## Service Information Bulletin

### **Introduction of 3 optional hardware components: New collimator handgrips, redesigned handle switch button and new upper column cover**

DX-D 100 / DX-D 100 Wireless

**UPGRADE HANDLE COLIMATOR MOBILE 3.0 AND 3.1**

Figure 3

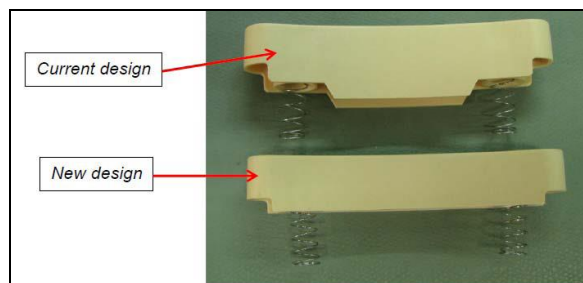
The switch button inside the handle is redesigned to protect the wires connected to the switch of the handgrip. Additionally there is a new metallic plate as protection for the wires included in the revised switch.

In the case that the switch should be replaced order the switch upgrade kit with order number SC+A521491-019. The kit includes:
